SHOREHAM - BUDGET - ADDISON
 F 017-1(2)
 DRAINAGE SHEET No. 10 OF 11

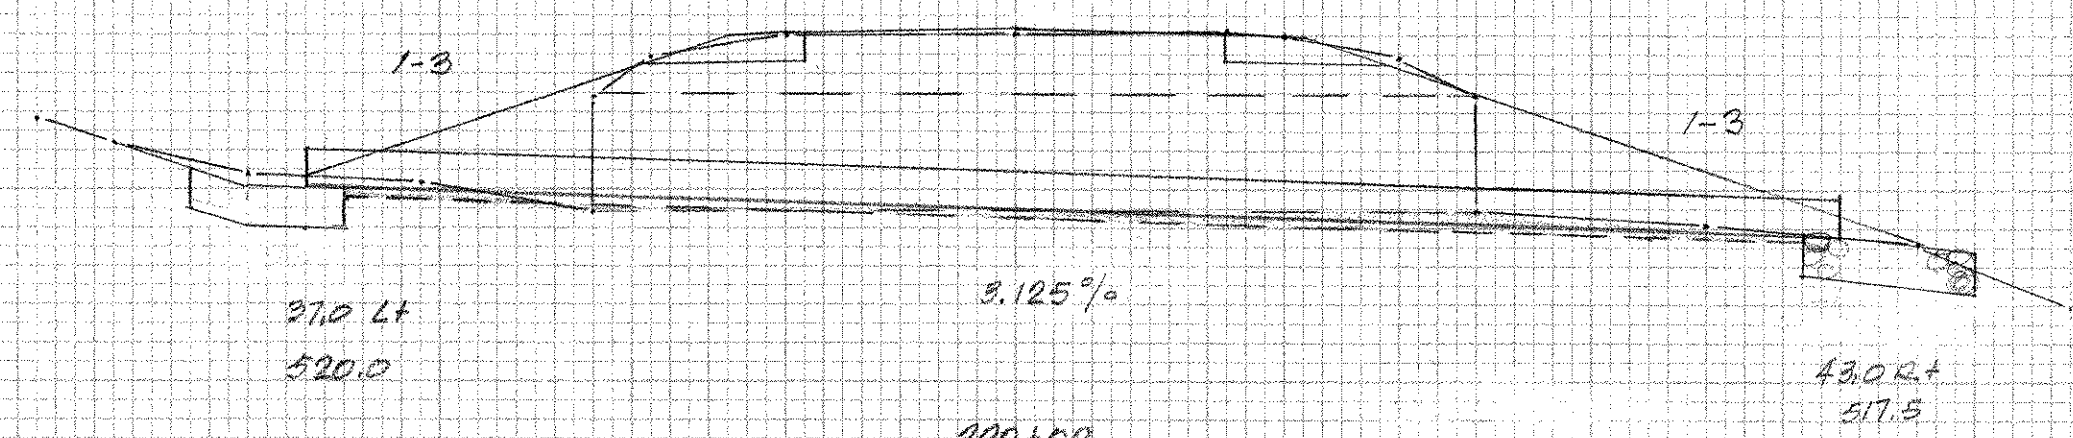
3.125%
 320+00
 REMOVE EXISTING 12" CAME PASS
 NEW 24" x 20" PCCSP
 BK 2E x 43

TRENCH EXCAV (Temp 24" removal)
 $40' \times 4.1 \times 1.5 = 277 = 9.1 \text{ cy}$
 field
 miss. p/ou/ro
 see

TRENCH EXCAV (New 24")
 $17' \times 4 \times 2 = 136 \text{ cf}$
 stone
 4.1 cf

STRUCTURE EXCAV (removal)
 $(300 \text{ sf} \times 12.1) - (\frac{6^2}{2} \times 15.46) = 277 = 122.1 \text{ cy}$

Jard Borrow
 $77 \times 0.5 \times 12.1 \times 1/27 = 17.3 \text{ cy}$
